**DELAWARE ARMY NATIONAL GUARD  
BUILDING ENVELOPE AND KITCHEN PLUMBING UPGRADES  
PIGMAN READINESS CENTER  
601 BRIDGEVILLE HIGHWAY  
SEAFORD, DELAWARE 19973  
DEARNG #20-2016 ❖ DFM #MC7601000092  
JUNE 5, 2017**

**ADDENDUM NO. 3**

**SK-2**

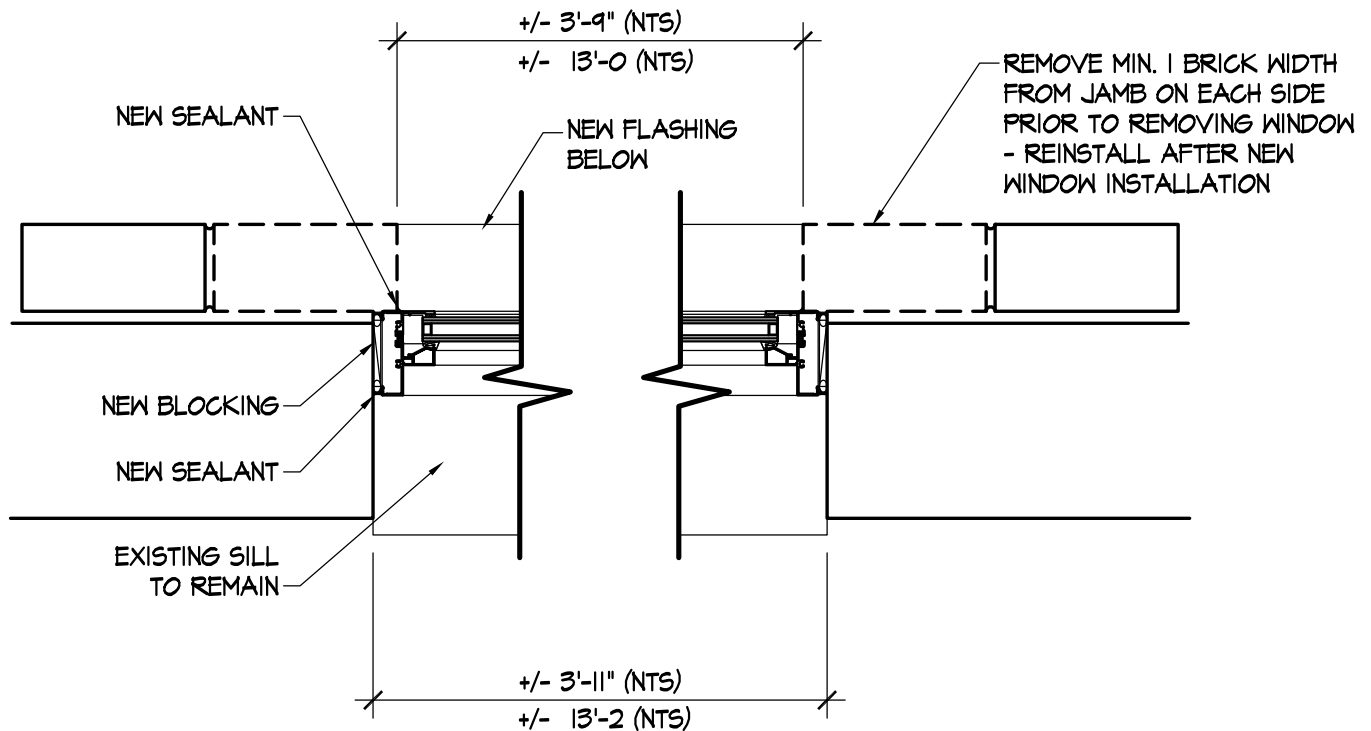
- Item No. 4      Clarification - Detail E7/A3: The interior rough opening dimensions are larger than the exterior dimensions noted for window types A, B and D on Sheet A3. The interior rough opening dimensions for types A and D is 3 foot 11 inches wide by 4 foot 5 inches high. The interior rough opening dimension for type B is 13 foot 2 inches by 4 foot 5 inches high. The GC will need to remove a minimum of 1 brick width from each jamb to remove the window and reinstall the brick after the new windows are installed, see attached Sketch SK-2.

NOTE: GC SHALL FIELD VERIFY ALL ROUGH OPENING DIMENSIONS PRIOR TO ORDERING WINDOWS.
